# GROUNDING REVIEW

**Dr. John Delderfield**

SPIRE SYSTEMS ENGINEER

# Position at Instrument Intermediate Design Review, April 2001

# Overall Block Diagram

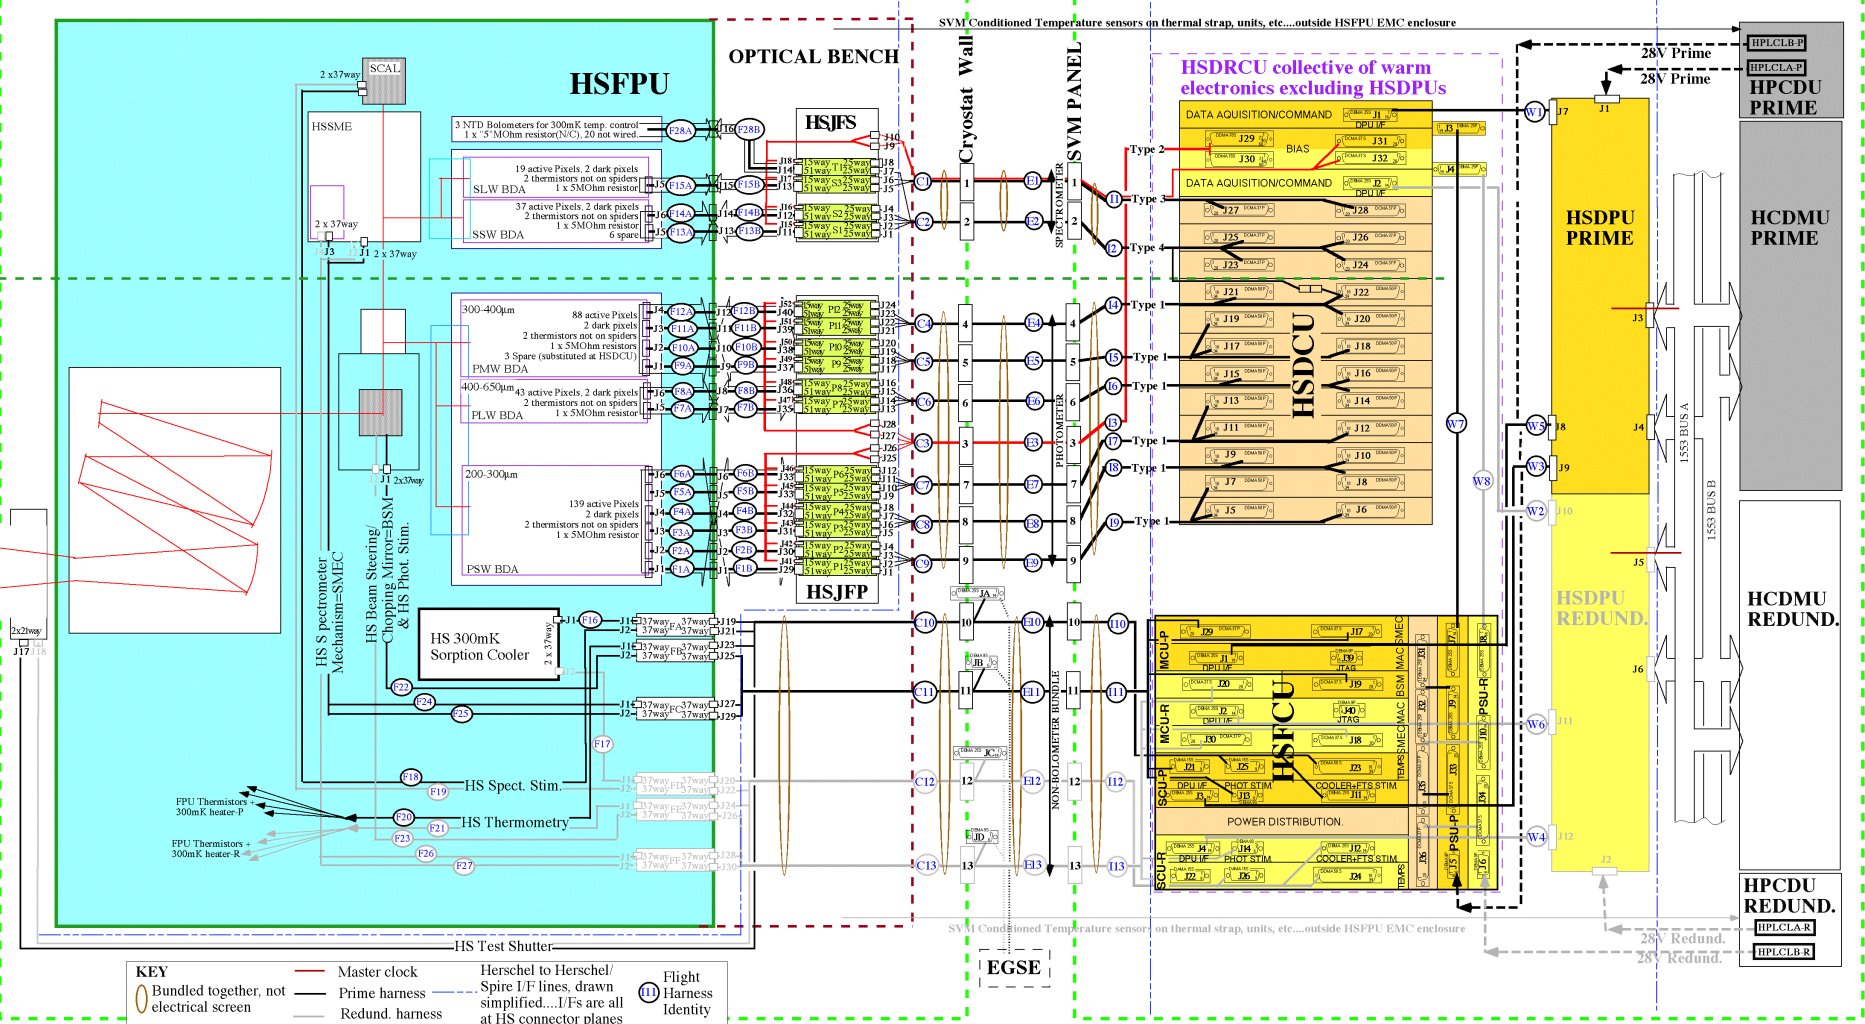
- KEY**
- Bundled together, not electrical screen
  - Master clock
  - Prime harness
  - Redundant harness
  - Herschel to Herschel/Spire I/F lines, drawn simplified...I/Fs are all at HS connector planes
  - Flight Harness Identity

## HERSCHEL SPIRE GROUNDING SCHEME

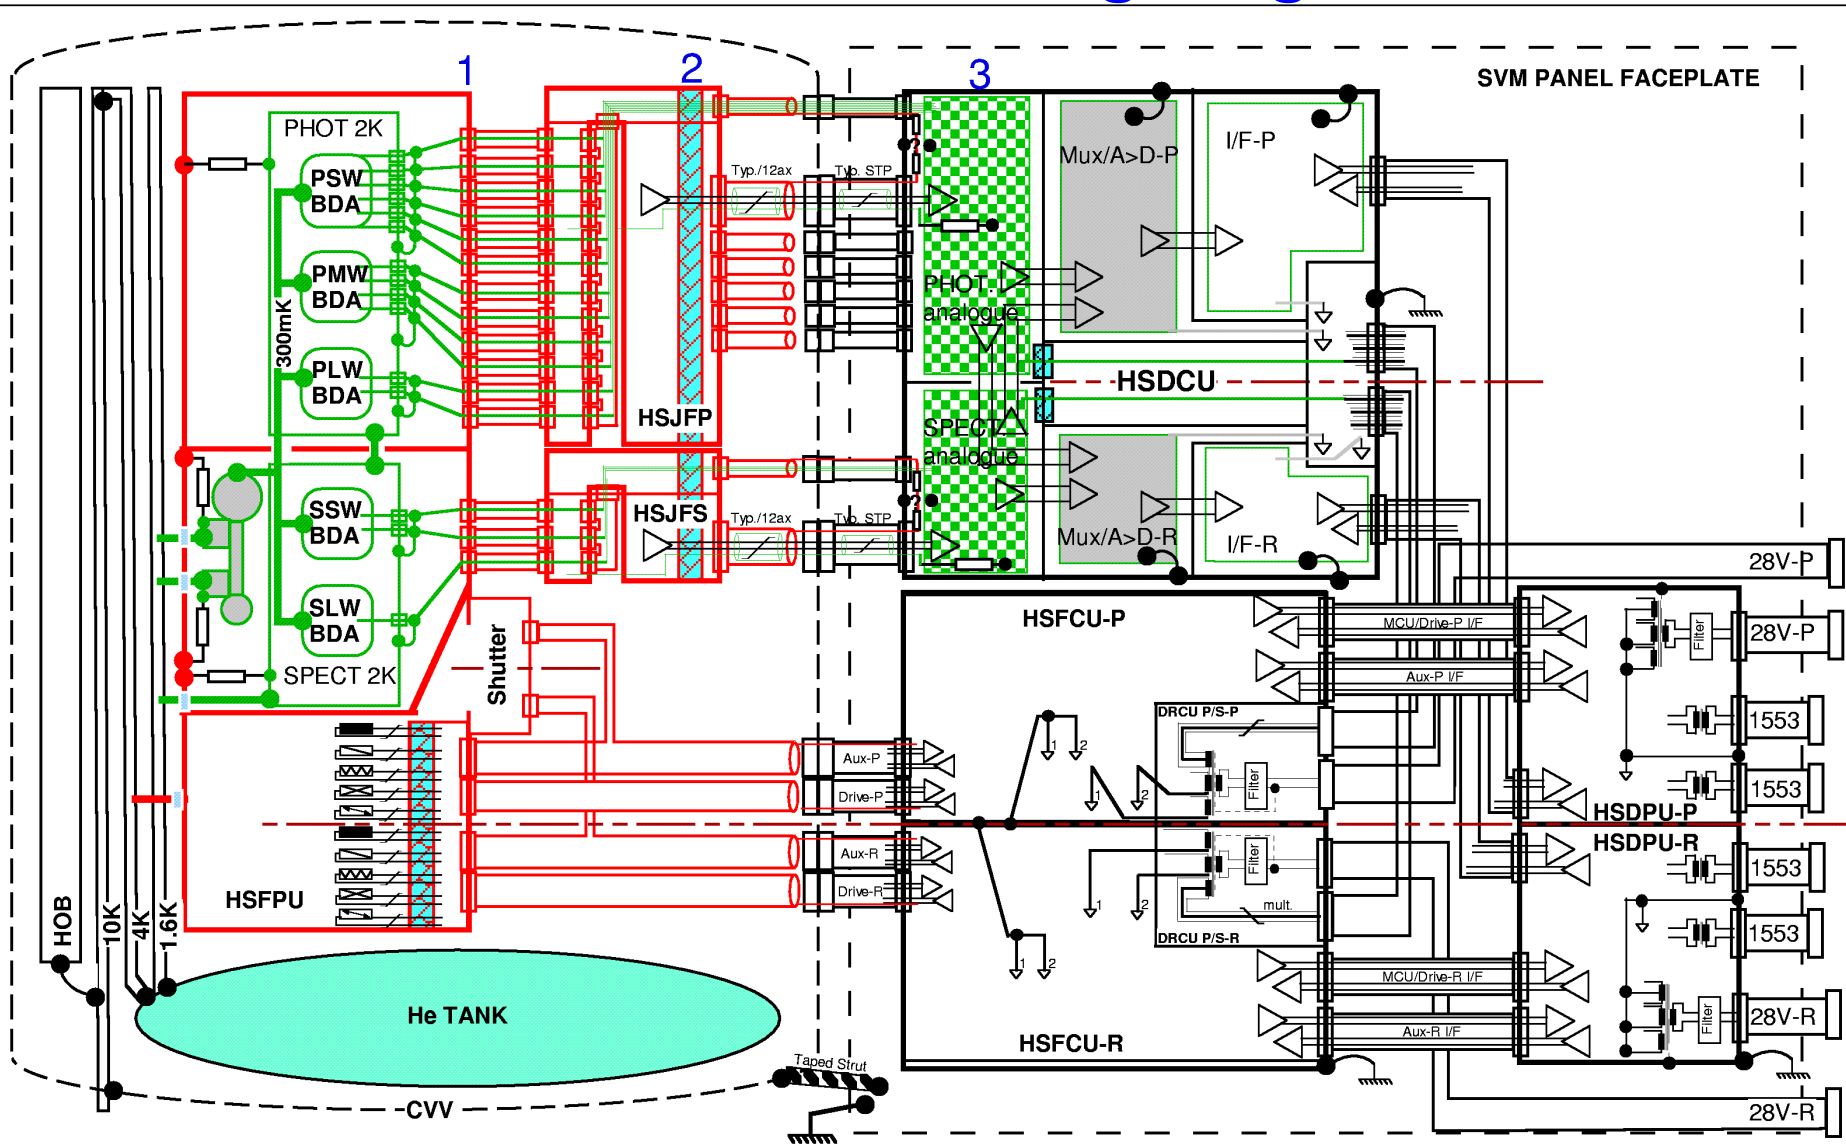
- All HSFPU electrical items isolated from chassis. Together with the JFETs, the HSFPU forms a Faraday cage aimed at preventing the bolometers receiving wire or field-coupled stray energy.
- Conventional grounding of HSFCU, HSDPU, and other than the analogue front-ends of HSDCU. All non-bolometer loads in HSFPU are driven balanced.
- Analogue photometer and spectrometer front-end grounds are split so as to minimise loop areas caused by having two JFET units.
- All bolometer systems, bias and amplifiers, are run differentially, but note potential imbalance in R.F. filters.
- Still to decide on grounding at 1, 2 or 3, and to confirm open shields inside CVV connectors/need for internal shields. More detail to follow in EMC presentation.

- i. the link between bolometer bias ground and chassis was still to be at a choice of 3 positions, but the hardware maintained low temperature hardware ground links
- ii. I had just removed question marks on the DRCU power supply grounds for the review!

**HERSCHEL SPIRE  
GROUNDING SCHEME**

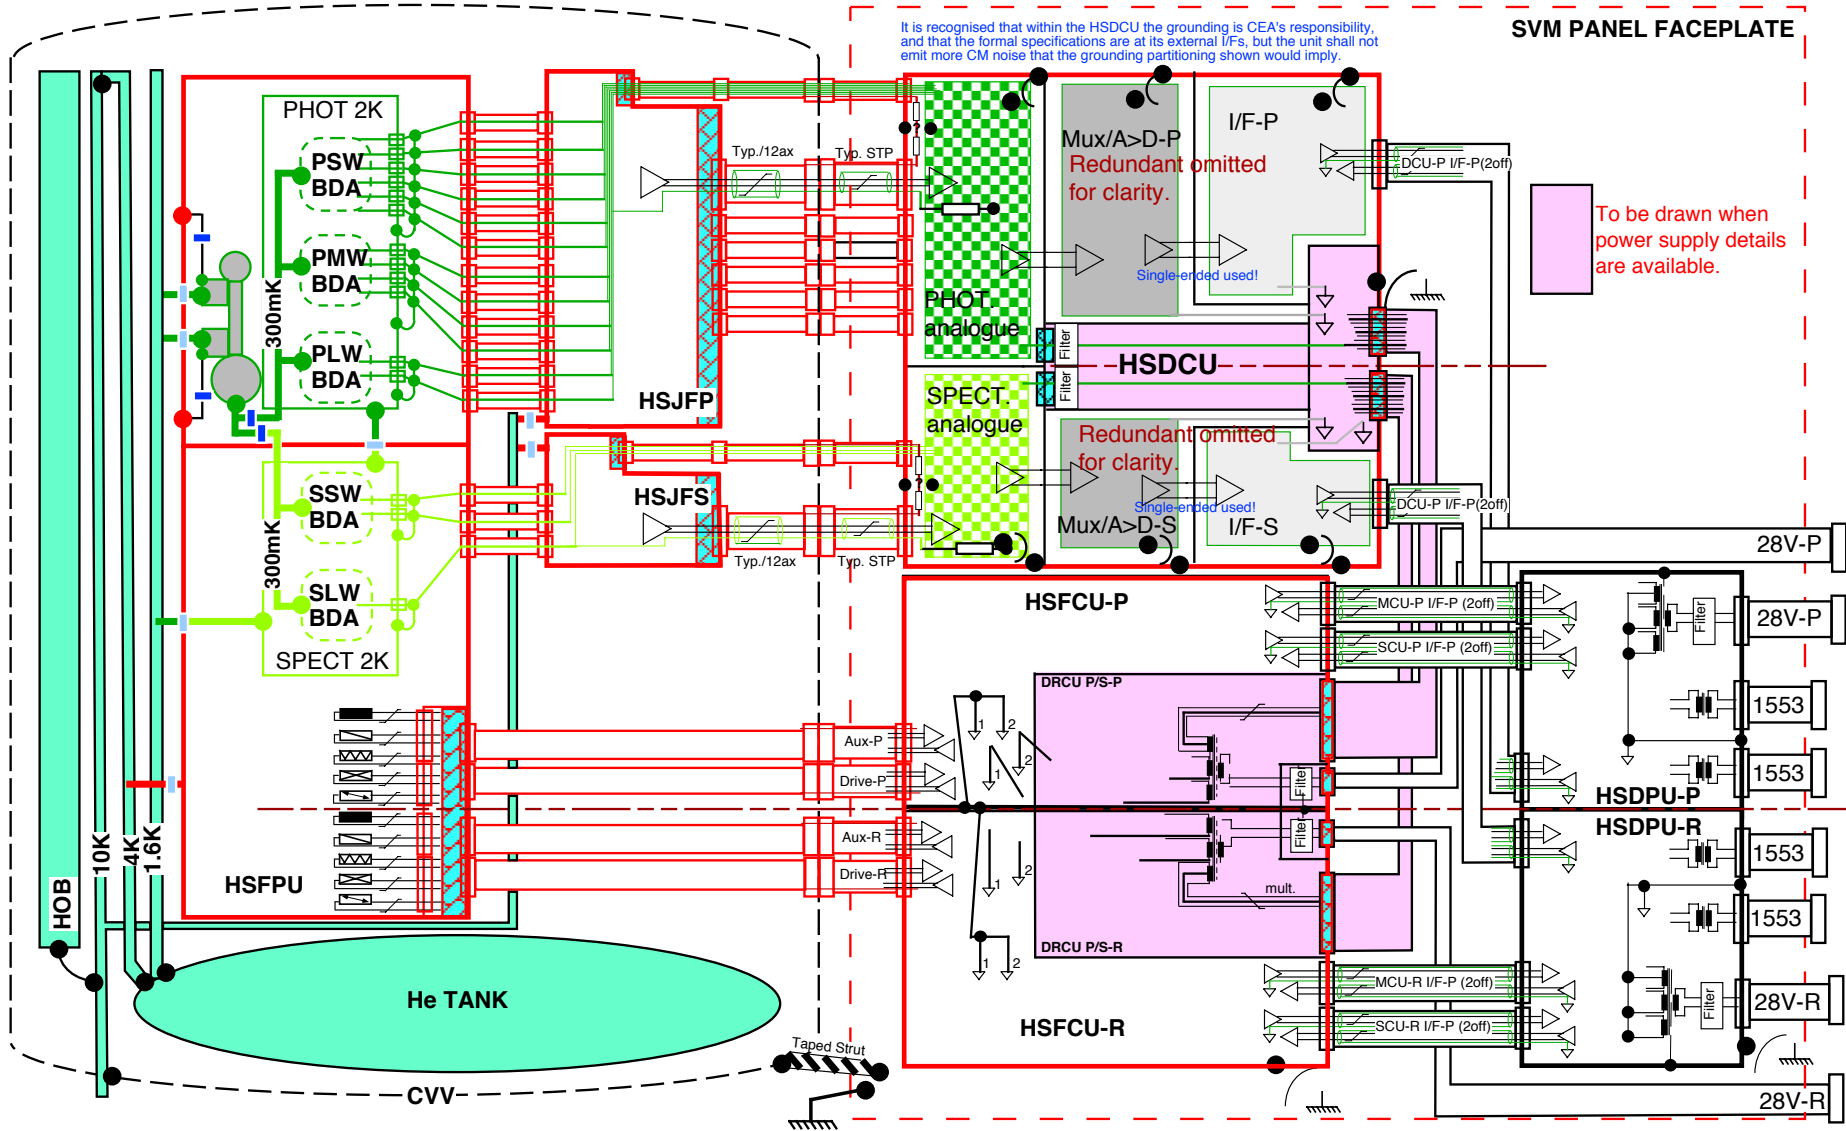
It is recognised that within the HSDCU the grounding is CEA's responsibility, and that the formal specifications are at its external I/Fs, but the unit shall not emit more CM noise than the grounding partitioning shown would imply.

## Changes since Overall grounding scheme version of 5th June.

- Shutter removed.
- Joined up instrument Faraday cage, see increase in red lines, by re-connecting shields at CVV wall.
- Made resistors in Faraday shield link wires very narrow line because they would not be fitted in this scheme. I am assuming that the wire's fractional contribution to heatleak is small and that just running totally inside a Faraday cage they cannot be a source of pickup. Besides the test harness layup is made.

- Removed all grounding option numbers as we are being forced at this stage to define one baseline.
- Remove 2K detector box resistances to HSFPU chassis. This scheme requires the mountings be "isolated". Put isolation in 2K box link...would separate S/C strap be easier?

- Reposition 300mK pump in drawing to show it more correctly on the Photometer side.
- Put in 300mK ground breaks, distinguishing between sapphire and other ground breaks.

- Simplify way backharness with bias grounds is drawn.
- Add ground LINKS from LIA analogue ground to HSDCU chassis, previously only a "can we include as an option to try" link.

- Change Spectrometer ground colour so no-one can assume it's the same as the Photometer!
- Remove cross-feeds from Spectrometer LIA to Photometer, and visa versa, which where a left-over from old ideas.

- Add note giving CEA flexibility within HSDCU.
